STATE OF MAINE
DEPARTMENT OF TRANSPORTATION
16 STATE HOUSE STATION
AUGUSTA, MAINE 04333-0016

January 19, 2023
Subject: Acadia Gateway
State WIN: 017163.03
Location: **Trenton**
Amendment No. 5

SHEET NUMBER
C102

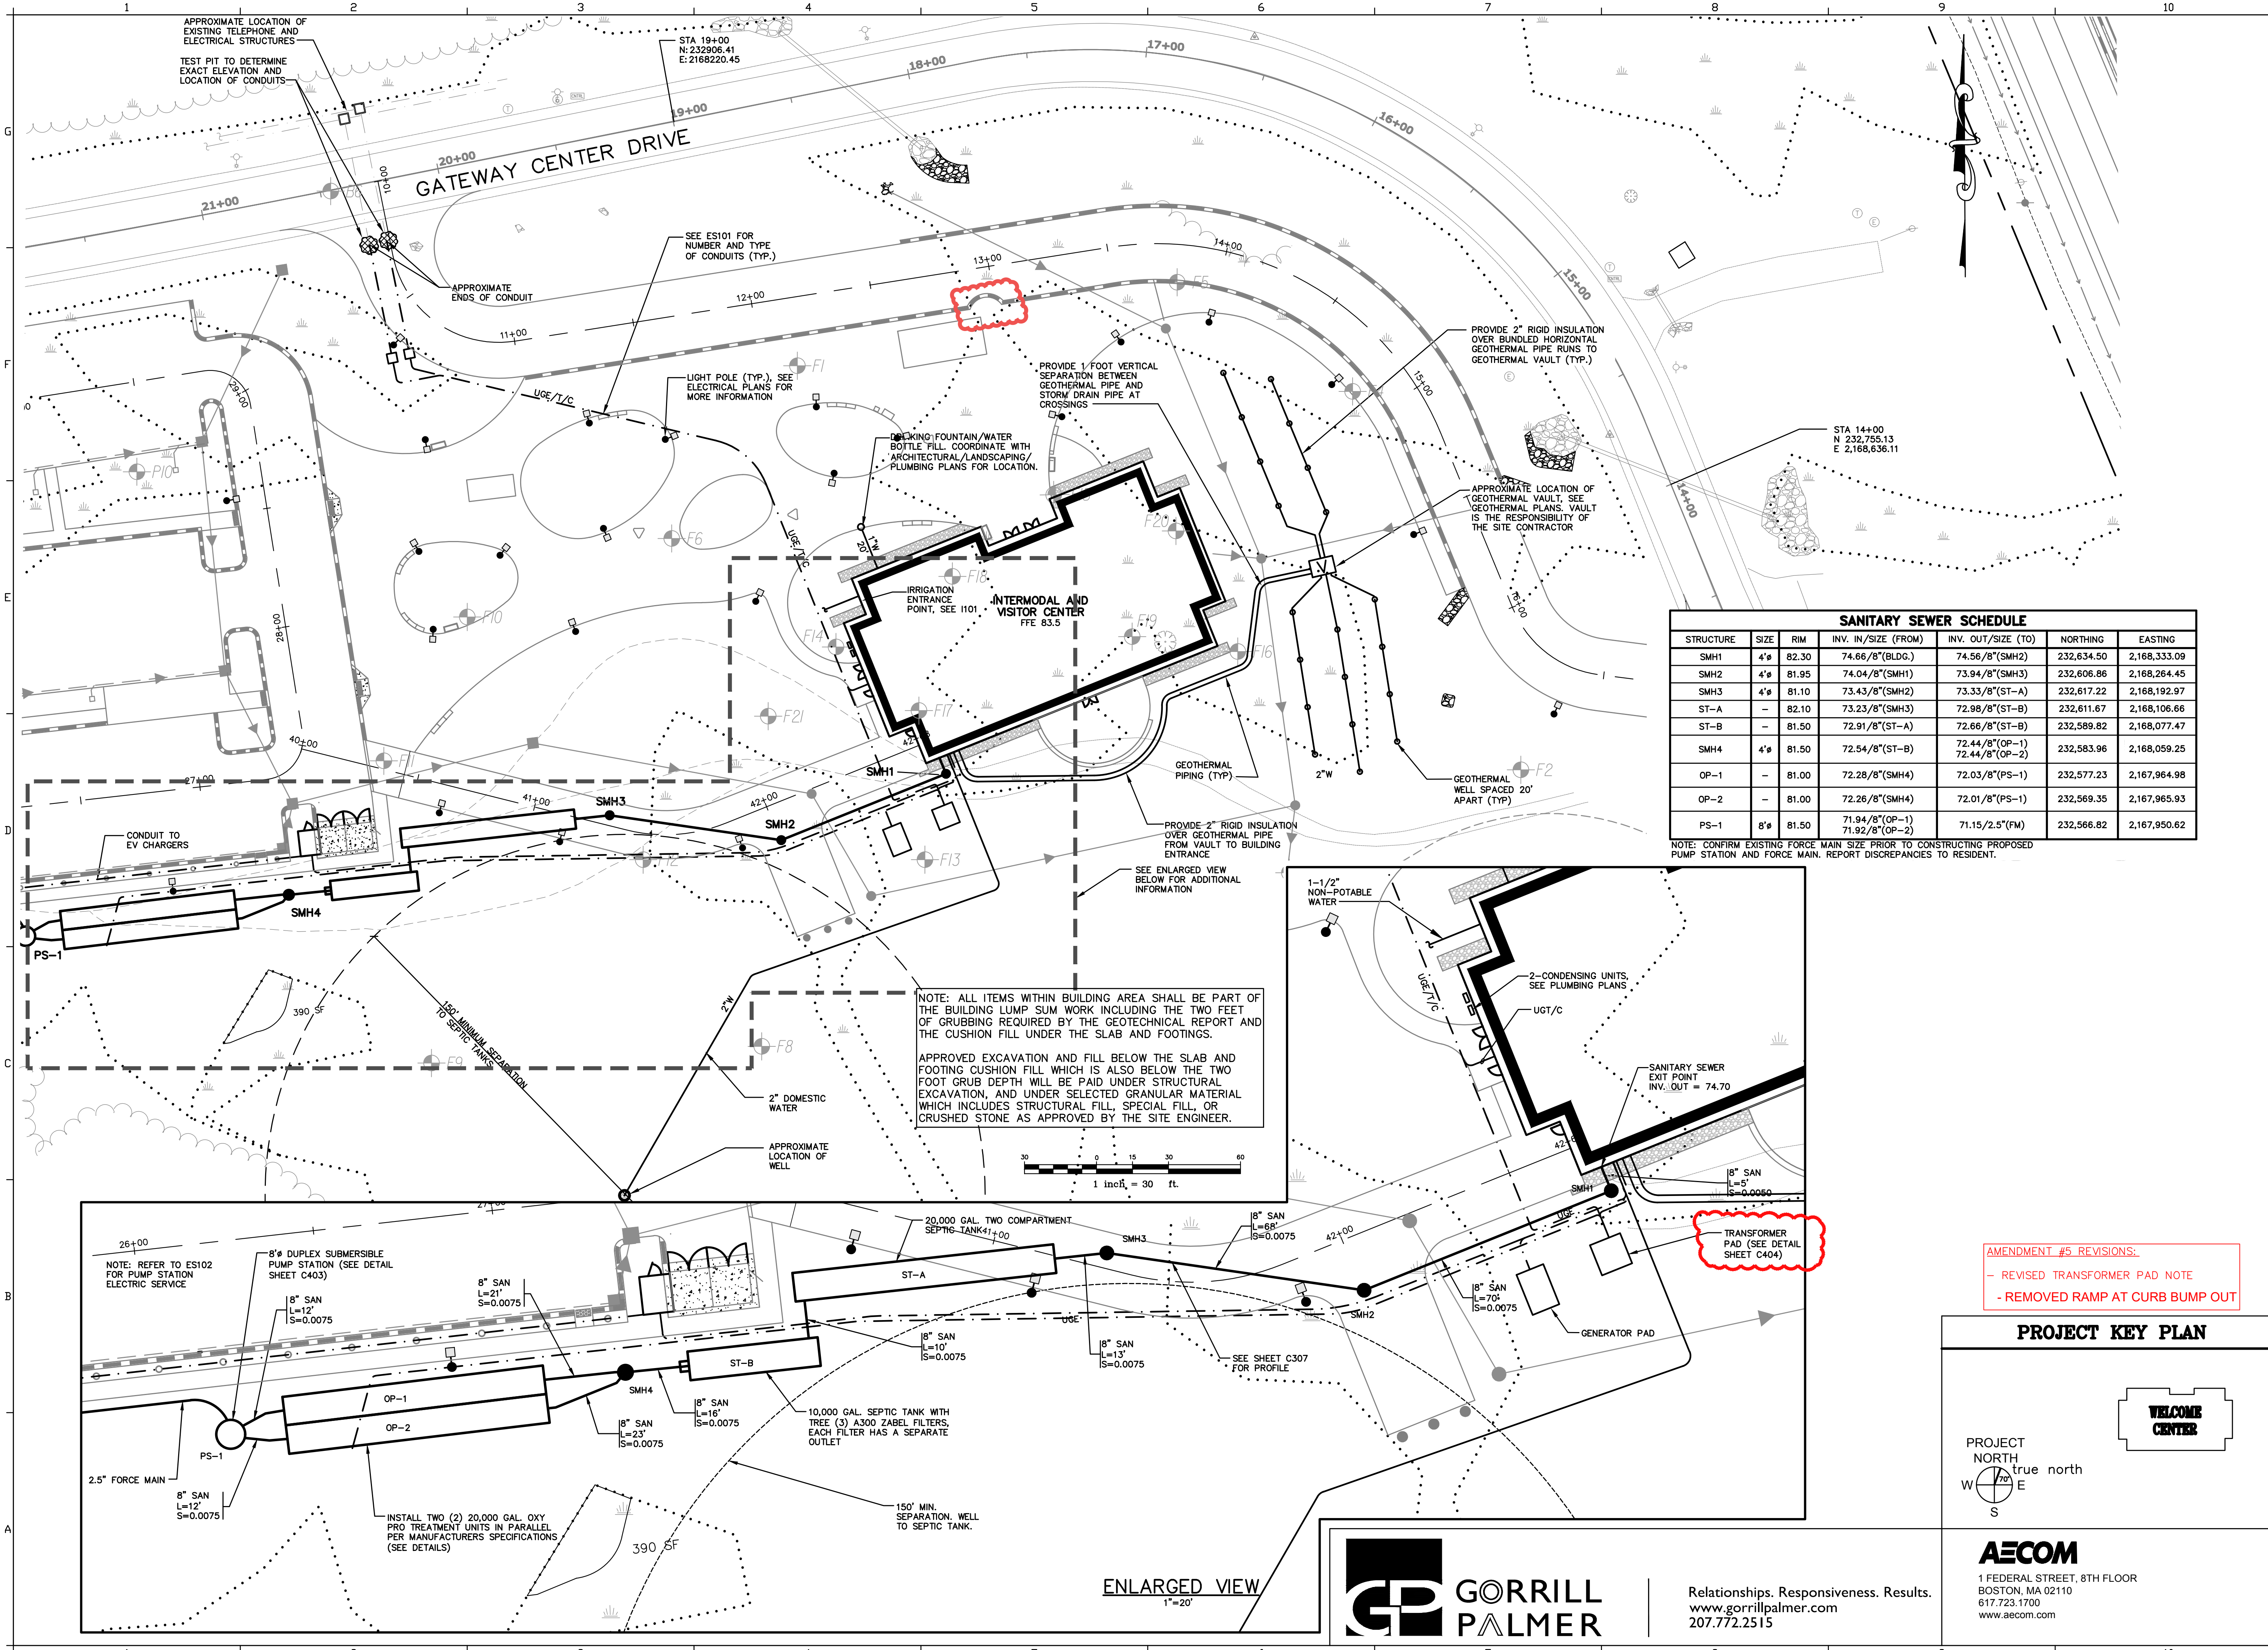
Question: On C302, a concrete area is shown on the north side of the roadway and bus access road intersection (near Sta 17+00 on the bus access road). Please provide details for this concrete work.

Response: The concrete area described is intended to be a raised concrete truck apron. A note has been added to sheet C102 and detail for this apron has been added to sheet C404 for clarity. Payment shall be made under item 502.342.
